Ottawa LRT Independent Review Report

April, 2022
Confidential

Mott MacDonald has been engaged by the City of Ottawa ("City") to provide Independent Review ("Independent Review") services regarding the Confederation Line LRT Stage 1 Light Rail Transit project (the "Project"), designed, built, and maintained by the Rideau Transit Group "Project Co."

Figure 3.8: Corrugation on Low Rail of Curve 210 at 104+725

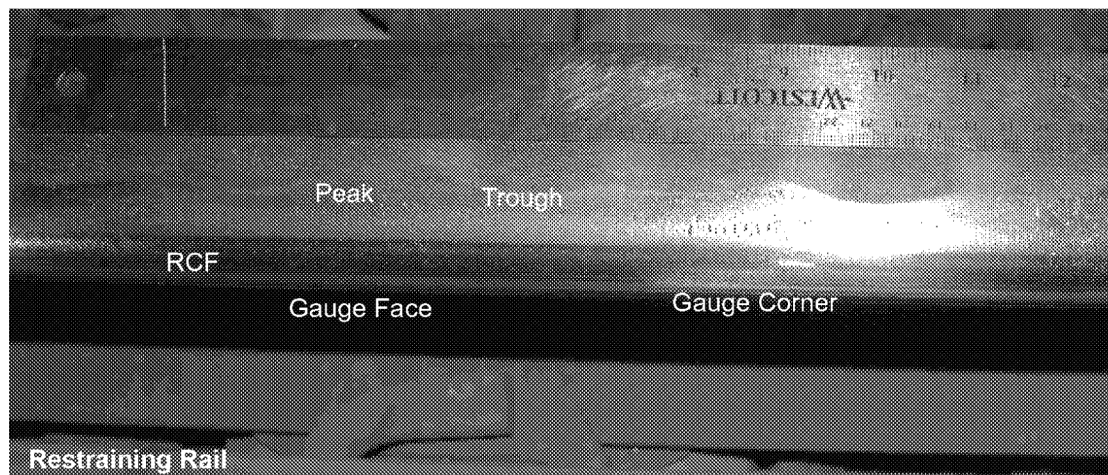
Corrugation on the low rail is located near the crown of the rail, **Figure 3.8**, **Figure 3.9** and **Figure 3.11**. There is also wheel contact on the gauge corner and the gauge face shown by the shiny polished surface. In contrast, corrugation on the high rails extends from the crown of the rail through the gauge and down the gauge face in the form of periodic side wear **Figure 3.10** and **Figure 3.12**. **Figure 3.12: Corrugation on High Rail of Curve 330 at 108+685** Figure 3.12: Corrugation on High Rail of Curve 330 at 108+685 shows two types of corrugation on the high rail, a long wavelength at the gauge corner with a shorter wavelength on the crown. There is evidence of plastic deformation occurring in the trough of the corrugation with plastic flow of the rail surface towards the field side away from the gauge corner, **Figure 3.9**. There is also some evidence of material breaking away “spalling” from the surface of the trough, **Figure 3.11**.

RCF in the form of head checks is present on the low rail on some curves, **Figure 3.8**, and **Figure 3.9**. No RCF is present on the high rail on the photographs examined.

Figure 3.17: Rolling Contact Fatigue on Low Rail of Curve 210 at 104+725

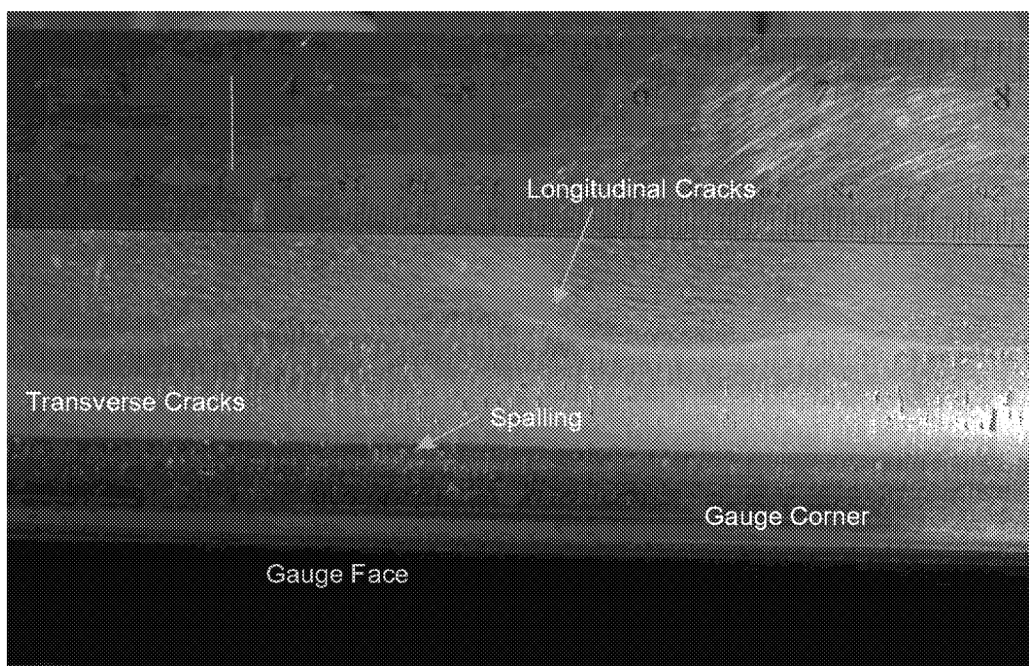
Observations of the photos from the site visit by Mott MacDonald has shown that RCF cracks are present on the surface of the low rail, **Figure 3.17** and **Figure 3.18**. There appears to be two forms of cracks on the rail, transverse cracks near to the gauge corner which are closely spaced and in places have joined up with material “spalling” from the surface. There are also secondary longitudinal cracks nearer to the crown associated with the location where the corrugation is present. The two forms of cracks and the running bands indicate that wheels are contacting the rail in two different places. One near the gauge corner where the contact forces are predominantly along the length of the rail and the second contact near the centre of the rail head where the forces apply transversely to the rail.

Wheel burns (sometimes referred to as engine burns), **Figure 3.17**, occur on the surface of the rail due to wheel slipping in the rail, they are often present on both rails at the same location and occur due to the increase in temperature resulting from friction. The high temperatures allow the surface layer of the rail to transform to a brittle phase which can initiate cracks within the rest of the rail. Although wheel/engine burns are not a form of RCF, they can lead to transverse cracks developing leading to rail failures. Therefore, the management of them is similar with visual and non-destructive inspection required to understand the length and depth of them to determine what further actions need to be undertaken.

Figure 3.27: As-built v Design Contact Wire Height – Eastbound Track

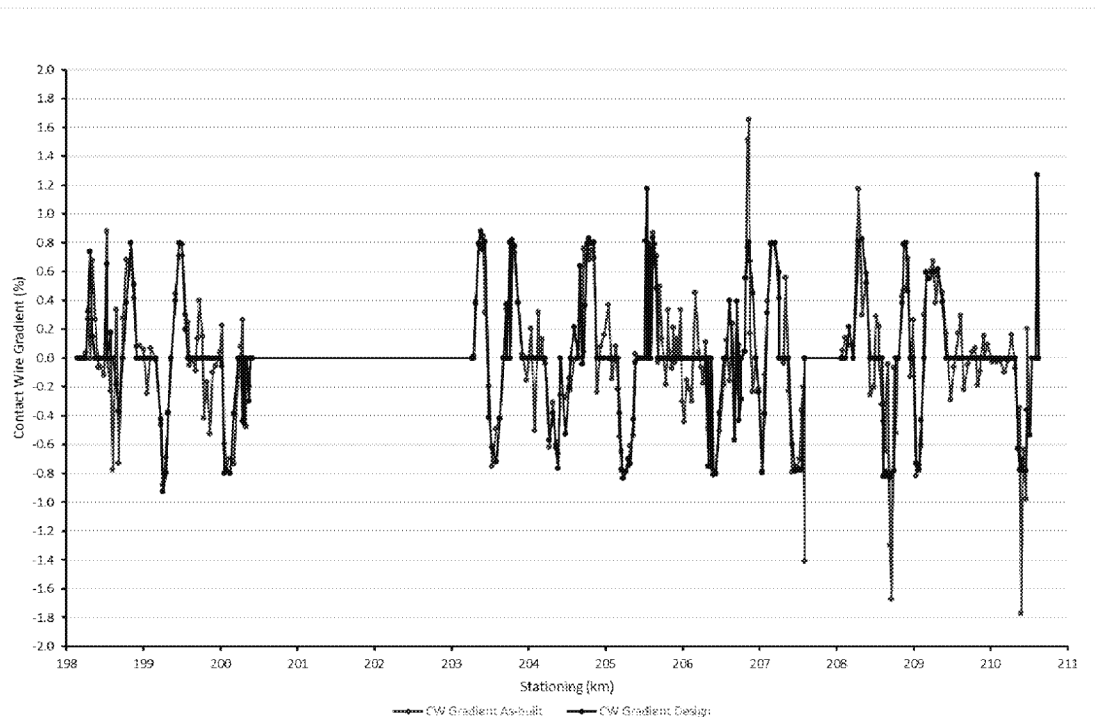
Contact wire heights were reviewed in both the eastbound and westbound directions. **Figure 3.27** is provided to show graphically the eastbound contact wire heights (and is a reasonable proxy for the similar westbound representation). The as-built profiles (in red) are typical to those presented in the Alstom report.

Figure 3.29: As-Built v Design Contact Wire Stagger – Eastbound Track**Figure 3.30: As-built v Design Contact Wire Stagger – Westbound Track**

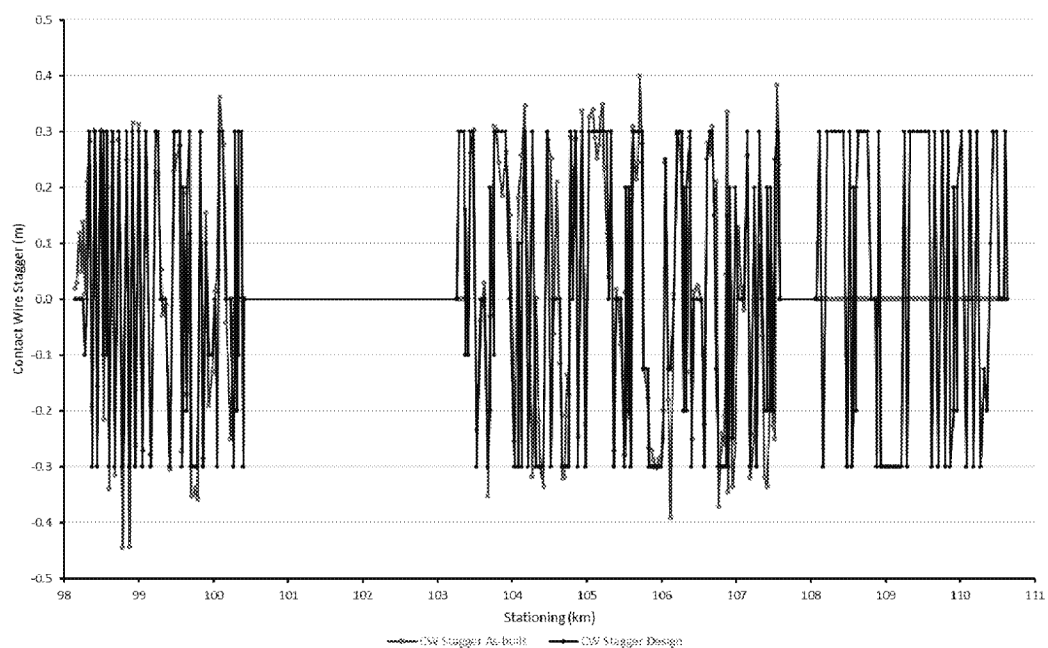
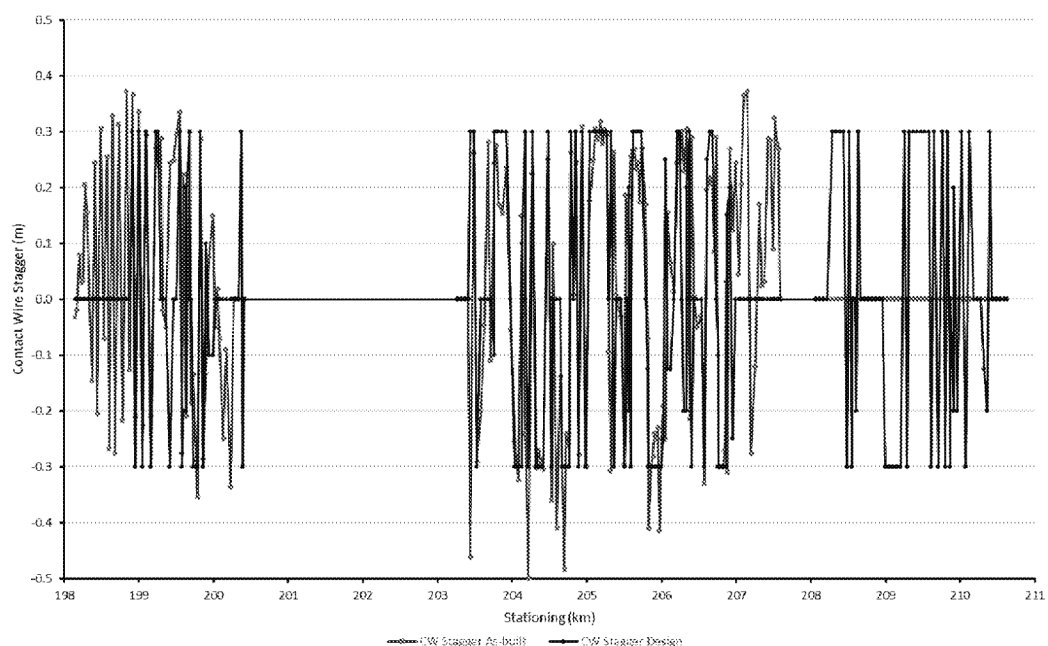
Based on the maximum allowable design gradient for the main line of 0.8%, it can be seen in **Figure 3.29** and **Figure 3.30** that there are areas where the design and as-built contact wire grading does not meet the requirements of the Project Agreement Schedule 15-2 Part 4, Article 8. The implications of excessive grading can be either a reduction or increase in the contact force on the pantograph, which can lead to:

The as-built contact wire stagger for both the eastbound and westbound tracks were compared with the design and are shown graphically in **Figure 3.29** and **Figure 3.30**.

Figure 3.31: RailPod Data V Design Contact Wire Height for Eastbound Track

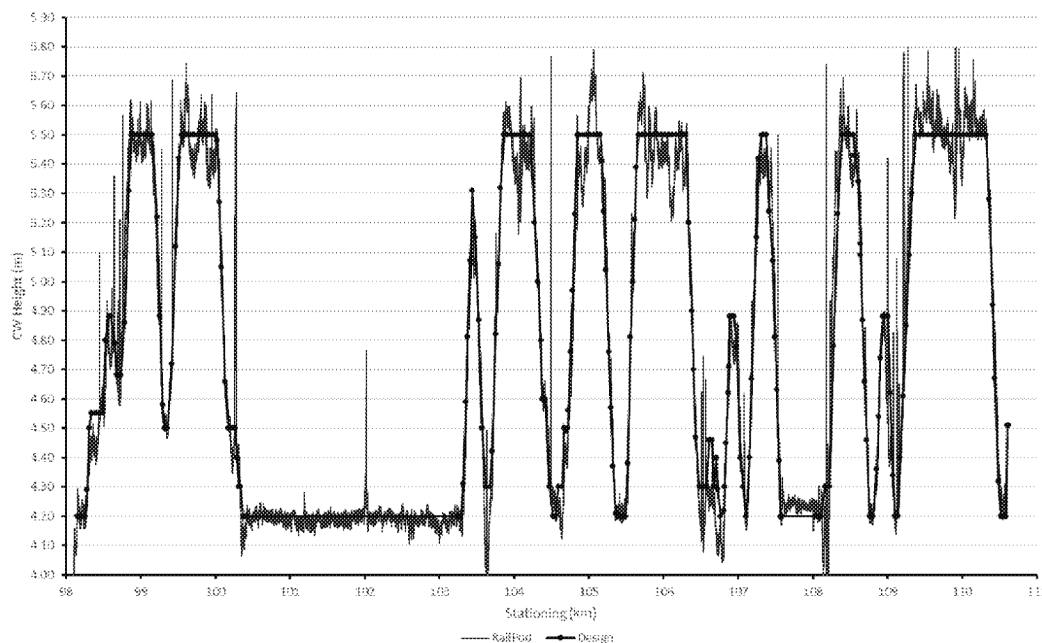
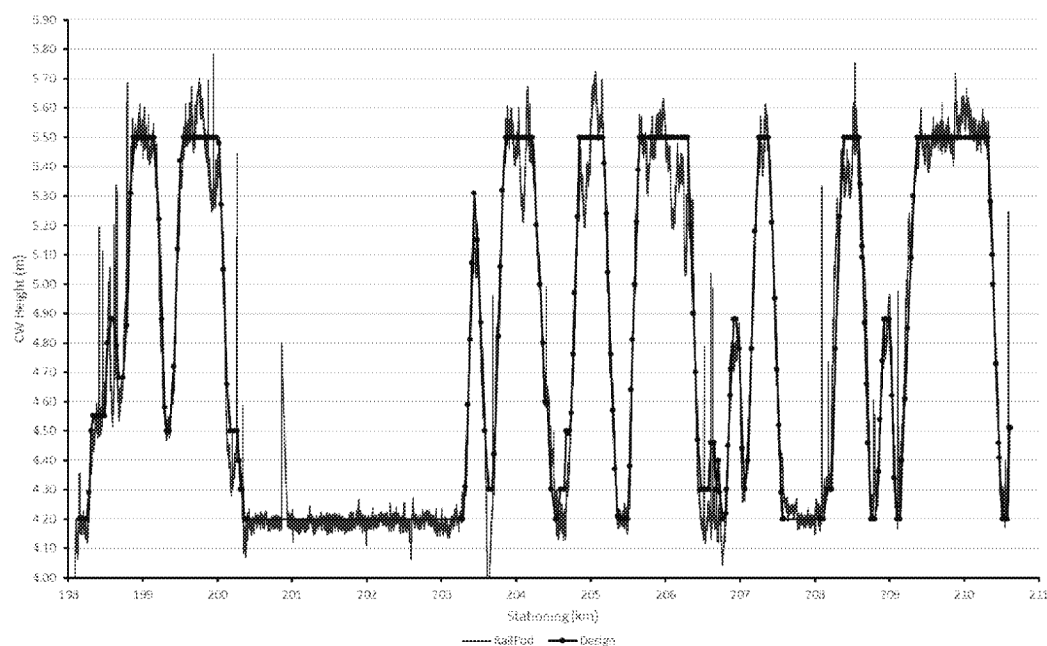
A comparison of the RailPod contact wire height data, measured in September 2020 and part in February 2021, for both the eastbound and westbound tracks, was compared to the Project Co design, similar to that in section 3.2.1.5 and are shown in **Figure 3.31** and **Figure 3.32**. Note that some spikes occur as shown within the RailPod data due to gaps in the OCS or potentially due excessive movement of the measuring machine and can be disregarded.

Figure 4.6: Sanding Pump at Track #7

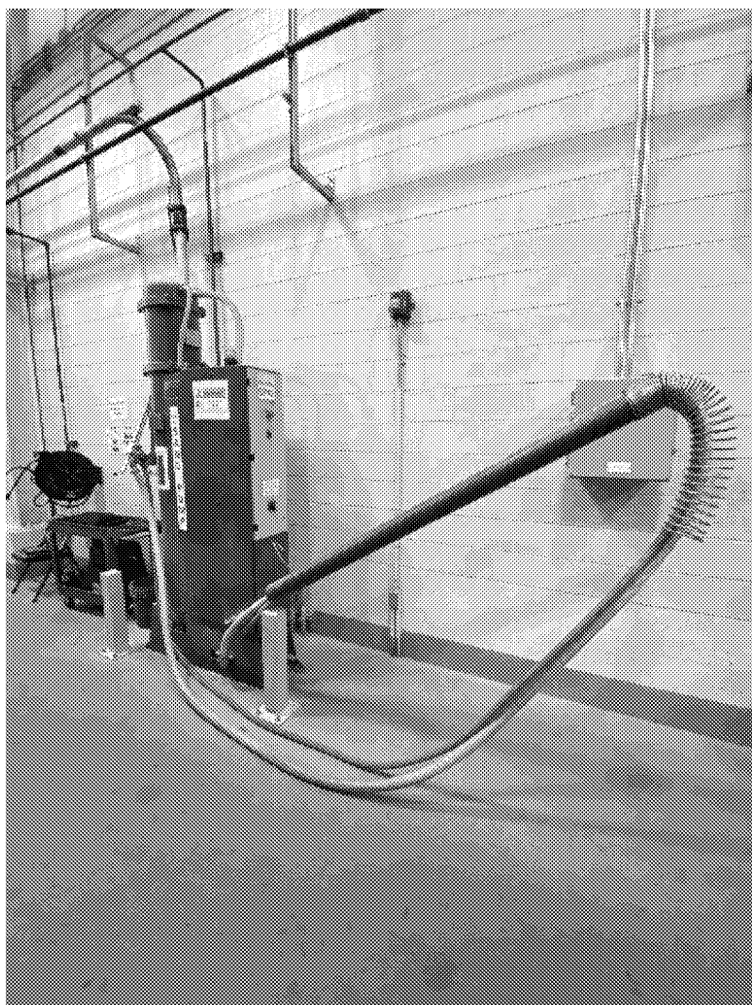
On track # 7, 12 sanding pumps are located, six on each side of the vehicle (**Figure 4.6**). Due to the location of the sanding pumps, the device was fitted with longer hoses to be able to reach the sanding box ports on the vehicle. The extra length on the hoses causes sharp edges and substantial rubbing with the floor, causing the hoses to break. This issue is controlled by the use of sacrificial conduits. The Mott MacDonald team was informed that the system suffers from constant clogs due to presence of moisture in the sand.

Figure 4.7: Carwash System at MSF1

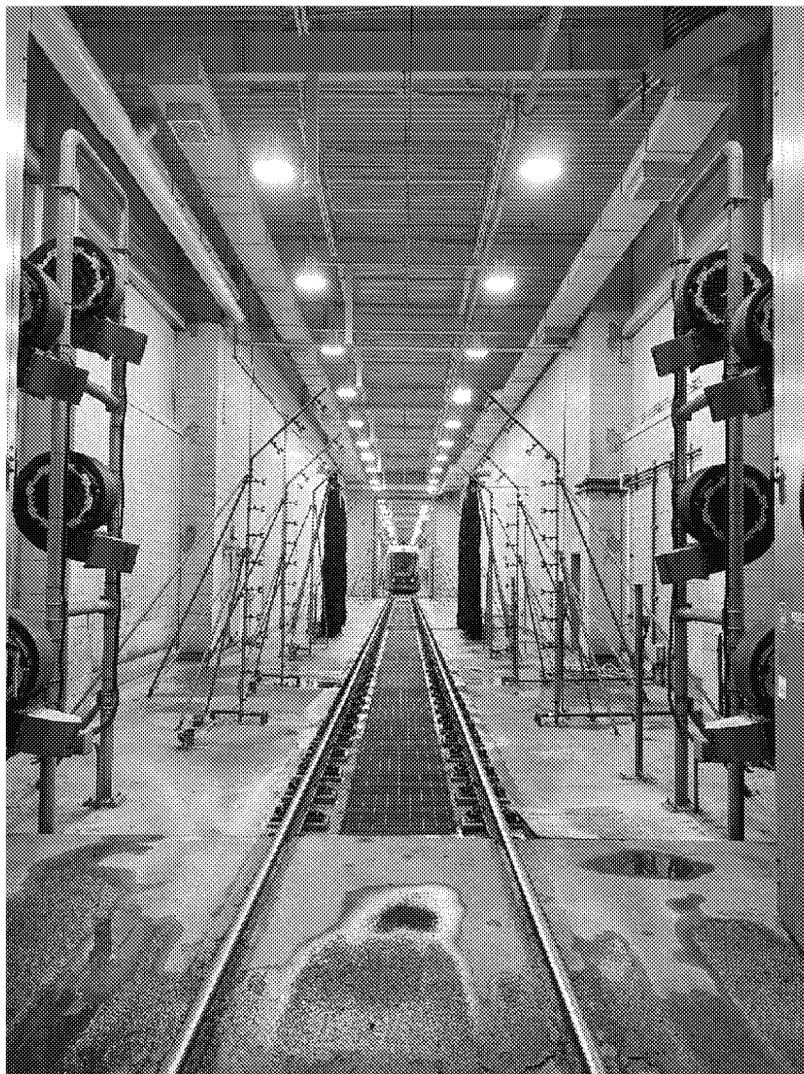
The carwash system is located on track #8 (**Figure 4.7**). The system can wash a consist of two vehicles without having to decouple the train, however, the system does not wash the front and rear cabs of the consist. Based on the Mott MacDonald team observations, the rinsing and blower systems' performance are not optimal, leaving the vehicle wet and with detergent residue as it leaves the carwash track. This may also create problems during the winter when water on the bodysides and doors may freeze resulting in possible door seals sticking and creating door reliability issues.

Figure 4.8: Other Potential Vehicle Launch Tracks

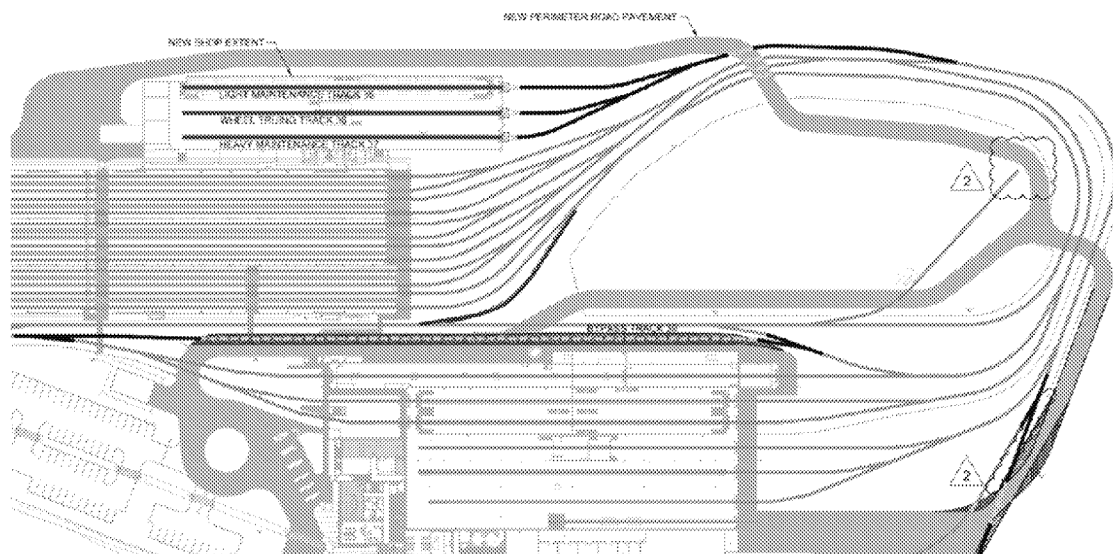
Other tracks could be used for launching vehicles for revenue service including bypass track 39 and track 22 (**Figure 4.8**). The Mott MacDonald team was informed that bypass track 39 is not used and has not been commissioned as it is part of the project's Stage 2. This constraint adds further to the limited operational efficiency and flexibility of the MSF track layout.

Figure 4.20: Sample Track Measurements

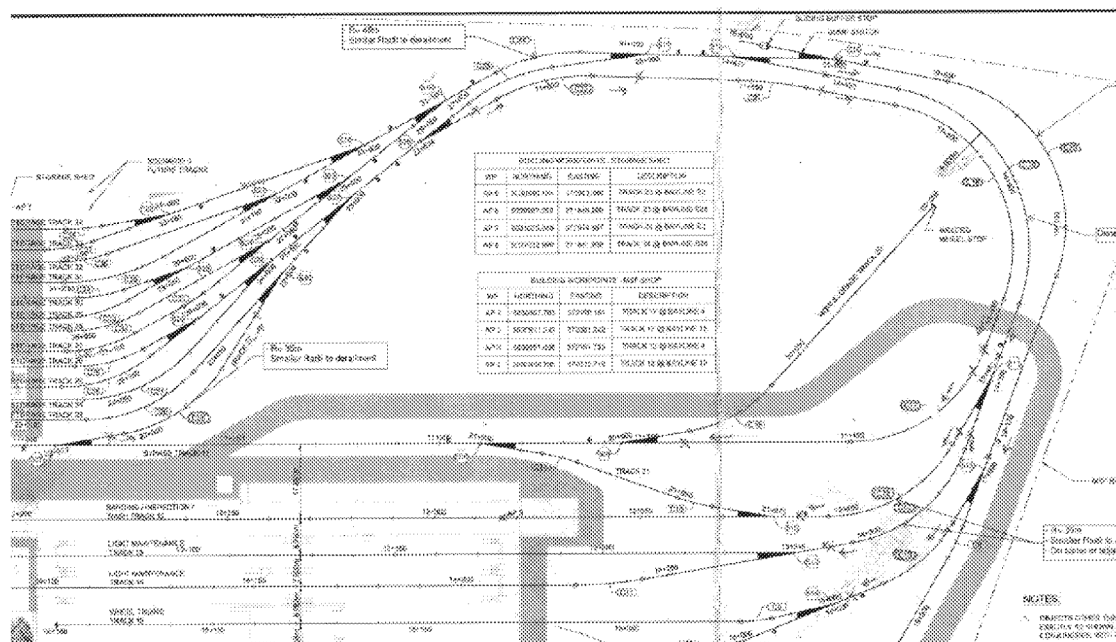
Figure Figure 4.20 shown below indicates the sections of track where the gauge has been measured, using a “Geismar model RTG-2” rolling track gauge. Measurements have been recorded manually in +/- 16th fractions from the standard gauge of 1435mm, e.g., a recorded +1/16 equals to approx. 1437mm. The main purpose of the gauge measurements was to determine whether there is a general trend toward tight gauge through the curves (below 1435mm) or gauge widening.

Figure 4.22: EB Connector, Track Geometry at Interface Between Ballast Track and DFF Track

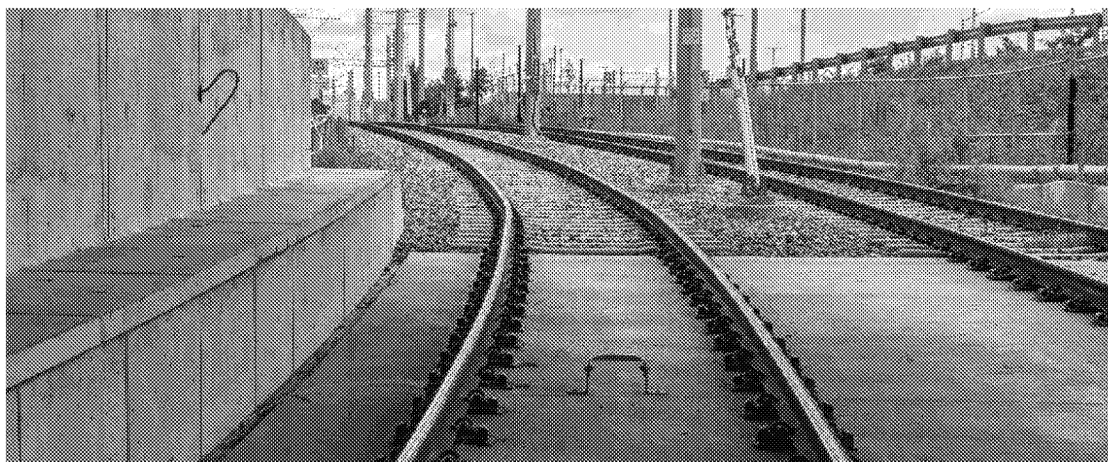
In addition to issues associated with the track gauge as listed in Section 4.4.1 above, general issues with the track geometry were found, most notably at the transition between ballast track and DFF track at the E/B and W/B Connector tracks (**Figure 4.26** and **Figure 4.27**).

Figure 4.24: Grooved Wear on Pantograph

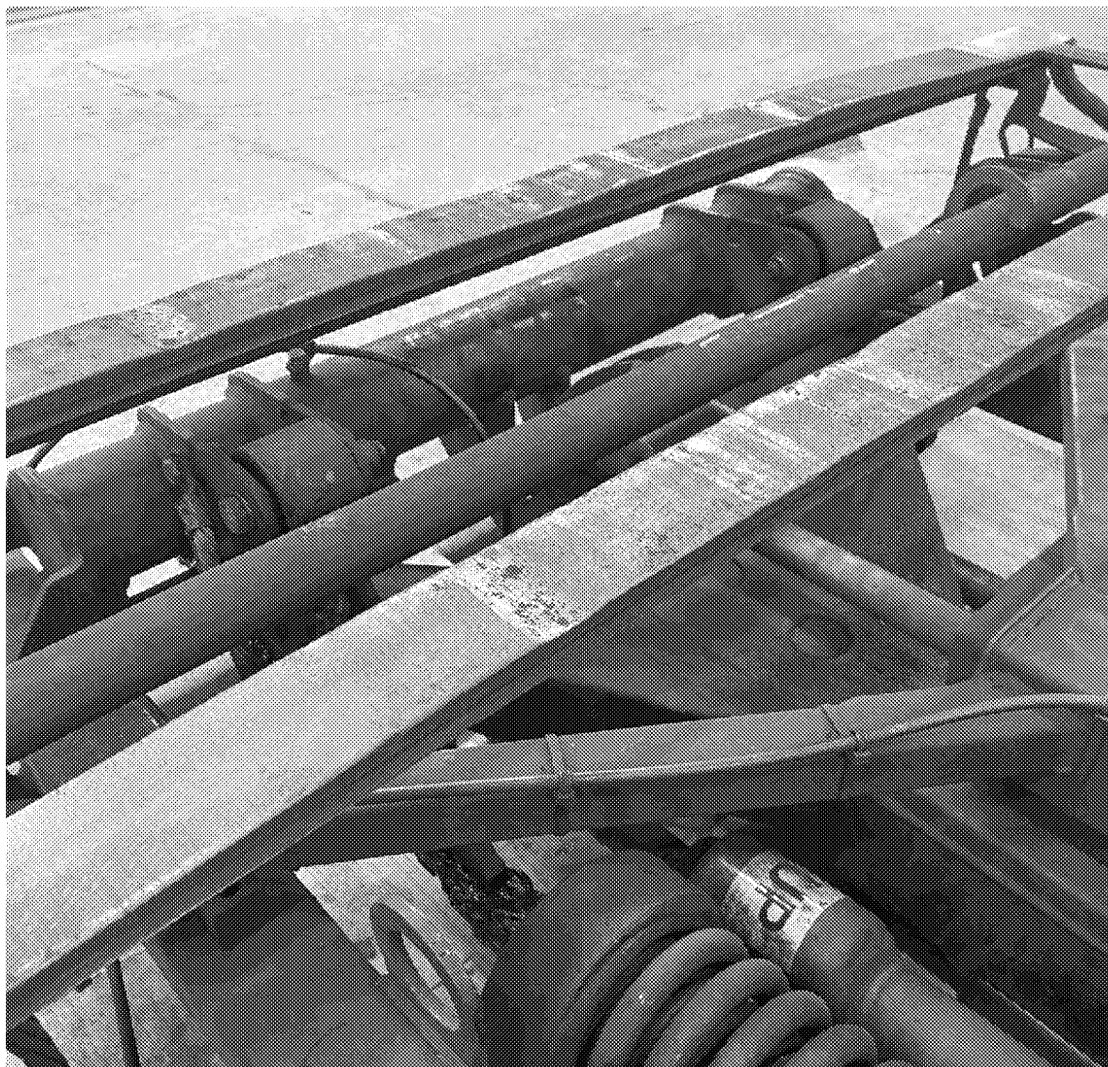
The amount of grooved wear on this example (**Figure 4.24**) does not appear to have improved from what was observed in September of 2020, but it is still noteworthy. A correctly adjusted OCS stagger should provide a more even wear pattern, with no distinct grooves.
